TECHNICAL BULLETIN

[Issue No.] FA-A-0174

[Title] Change in the D-sub connector of MELSEC-Q series modules

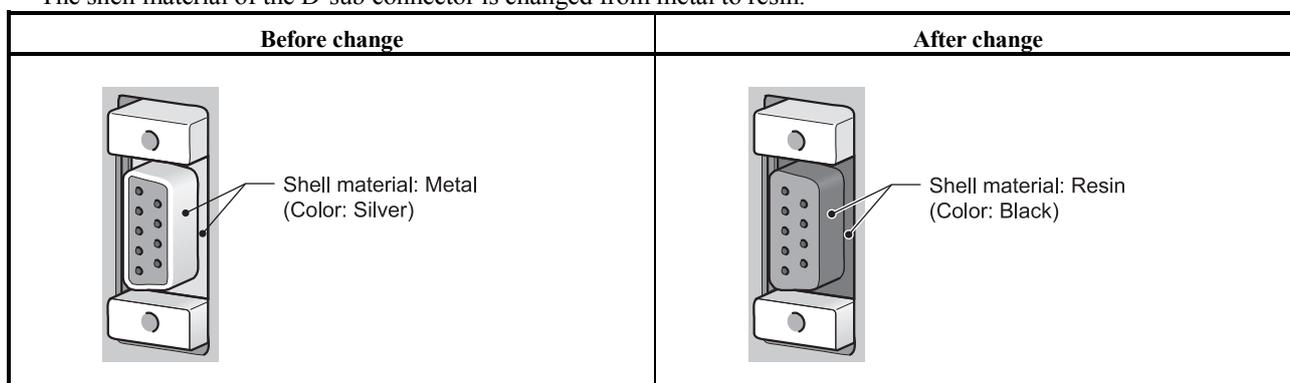
The shell material of the D-sub connector is changed from metal to resin.
